Design, Supply, Installation, Testing and Commissioning of 400kV Transformer Bay and 230kV Transmission Line Diameter Extension at Kaliakoir Substation

Clarification No.01

(23 July, 2026)

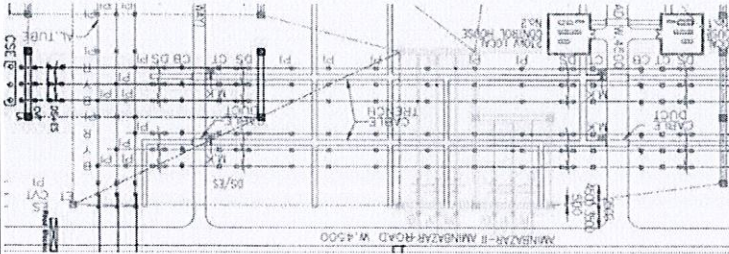
3	Volume 1 of 3	Price Schedule	Description: There is no line item for auxiliary transformer foundations in the price schedule. Bidder's Queries:	Added in price schedule: B-4	Y

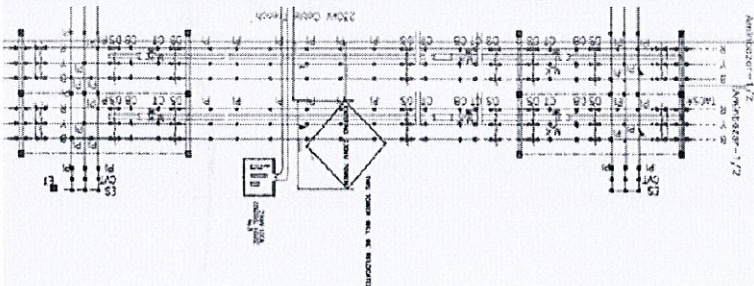
8	Volume 2 of 3	Volume-2_SS Part/ Section 1 7-Drawings/ Electrical Layout of Kaliakor 400/230kV Substation/Page -18/3	Description: In the Electrical Layout drawing of Kaliakair 400/230kV Substation, it is shown that the cable connection between the Transformer LV side and the 230kV Bay is through an underground (UG) cable system. Bidder's Queries: No technical information regarding the underground cable system has been provided. Please provide the drawing and details of the underground cable connection system.	230kV Power Cable GTP and Cable Trench drawings are attached in Addendum-1.	Y
